# JUNCTION LANDING

Design Review Recommendation  
4417-4423 42ND AVE. SW

Southwest Design Review Board - SDCI #3026661

## 2. EXCEPTIONAL TREES/OPEN SPACE

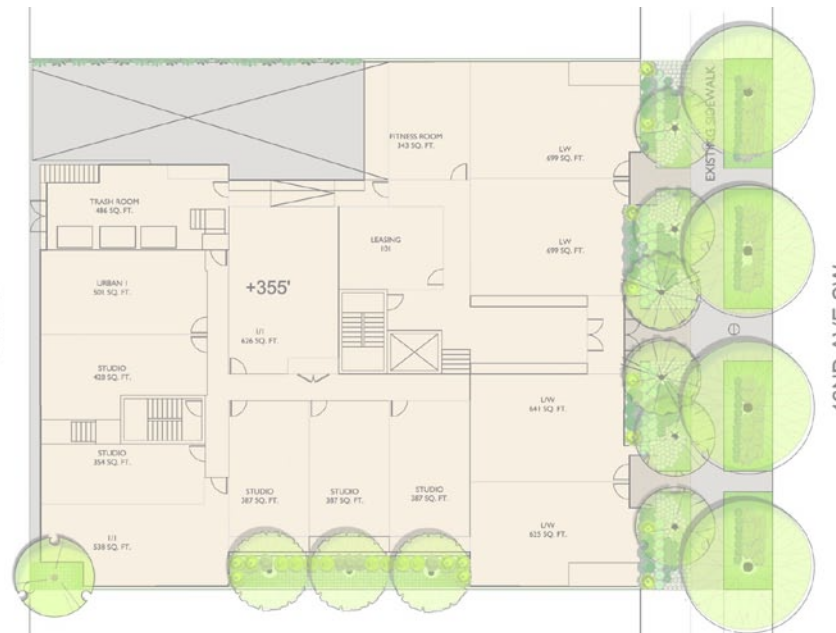
A. The Board was receptive to the removal of all three Exceptional trees on the site however they wanted to see further development of the landscape plan and how it creates a viable rooftop habitat. The Board requested the landscape plan include specific details on the tree species proposed, size of the trees at planting, especially on the rooftop amenity space, to convince the Board that removing all three Exceptional trees is appropriate due to the proposed diversity of landscaping proposed. (DC4-D, CS1-D)

*MUP Response: We are proposing landscaping on all sides of the project site to soften the transition between properties. The main elevation facing 42nd Ave SW will be lush with new street trees. The alley side will also have planters below the windows of units and provide privacy and greenery on the alleyway. The small courtyard to the south will provide relief and a break in the overall massing and house a required bio retention planter. Landscape and Civil have worked together to propose not only a feasible drainage and storm water system that will fulfill the strict requirement of the code, but also introduced a rich palette of native planting all around and in the rooftop deck.*

4. DRIVEWAY

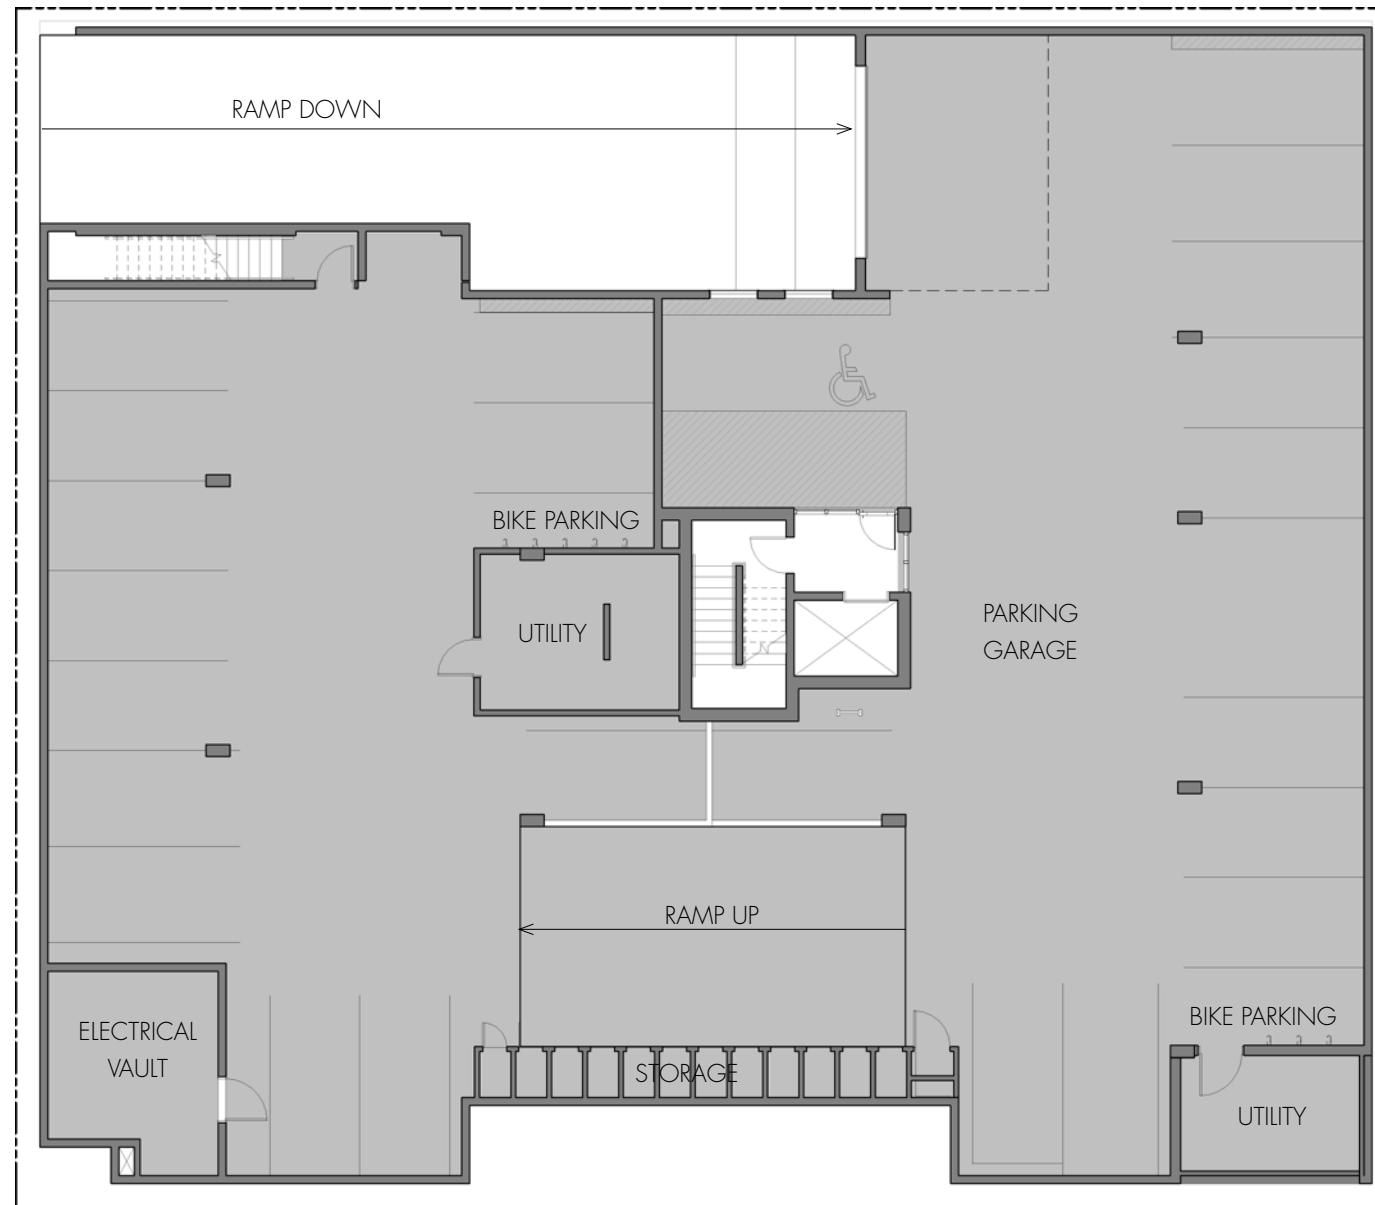
A. Acknowledging public concern, the Board would like to review additional information on the driveway access including a design for the fencing/railing being considered for safety purposes and how this will be aesthetically pleasing to the neighboring property. (DC1-B)

B. The Board had concerns with the driveway interaction with the alley, for safety and visual impacts, as the driveway will not be at the grade of the alley but downgrade, creating a void which will be very much present along the alley. The Board requested details of the building treatment of the walls on the east and south sides of the driveway to address the potential blank facade. (DC1-C)

MUP Response: We also acknowledge the desire for privacy and safety to the neighbor to the North and provided screening from the garage ramp in the form of an elegant wood and metal fence (setback from the property line to increase vehicle and pedestrian visibility), that announces the driveway from the alley and provide privacy to the resident's yard. The East and South side of the driveway were carefully designed like the rest of the building, paying attention to the break in massing through texture and color and providing a fair amount of glazing so that it is not a blank facade facing the neighbor to the north but also private enough due to the distance created by the ramp.
